Update on Rezoning Application No. 00476 for 1040 Moss Street (Art Gallery of Greater Victoria)
Bylaws Ready to proceed to Public Hearing

To: Council **Date:** November 24, 2015
From: Jonathan Tinney, Director of Sustainable Planning and Community Development
Subject: **Update on Rezoning Application No. 00476 for 1040 Moss Street (Art Gallery of Greater Victoria)**
Bylaws ready to proceed to Public Hearing
Changes to Accommodate Bicycle Structure

**RE: Art Gallery of Greater Victoria Renewal Project - 1040 Moss Street
Adjustment to Bicycle Enclosure**

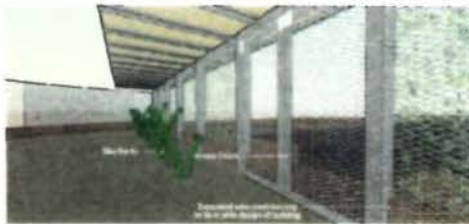
This is in response to City of Victoria Engineer Steve Hutchinson's concern about the existing chain link fence, that we had considered to be an integral part of the proposed bicycles enclosure, to be breachable, as the chain link fence could potentially be cut.

Therefore we propose a new semi circular expanded metal mesh wall added to the already proposed metal-mesh wall along the western end of the parking area. Together will form a secure bicycle enclosure, as required for the Class 1 bicycle stalls. All enclosure walls will be matching in materiality and height. Vines can be vertically grown in select areas on the walls, to provide visual accent. The shape of the semi circular wall follows the existing retaining wall within the permissible setbacks.

Please note that A. the previous Setbacks for the bicycle enclosure (the Accessory Building) had been measured to the roof edge, while the updated setbacks are now provided to the edge of the new expanded metal mesh walls and B. that the roof area has not changed in size.

SCULPTURE TERRACE - LANDSCAPE PLAN

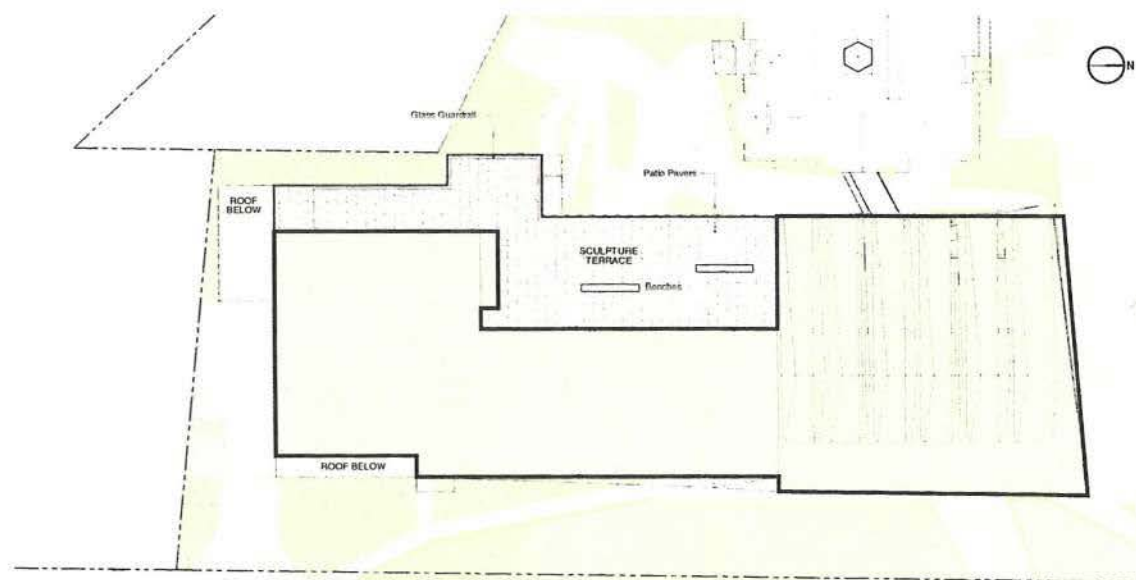
Panel Members discussed the need for a detailed plan of the plaza space as well as incorporating some hard surface materials other than concrete.

3. Landscape Finishes in the Plaza - drawing attached

- A detailed plan for the plaza is provided, including additional detail of the quality and finish of materials, definition of pavement and installation of electrical and lighting services to support various formal and informal public programs.
- The plaza surface materials and finishes will be an extension of the lobby providing continuity between the indoor and outdoor spaces.
- The proposal provides 12' wide folding/sliding doors from the lobby to create continuity between the lobby area and the plaza.
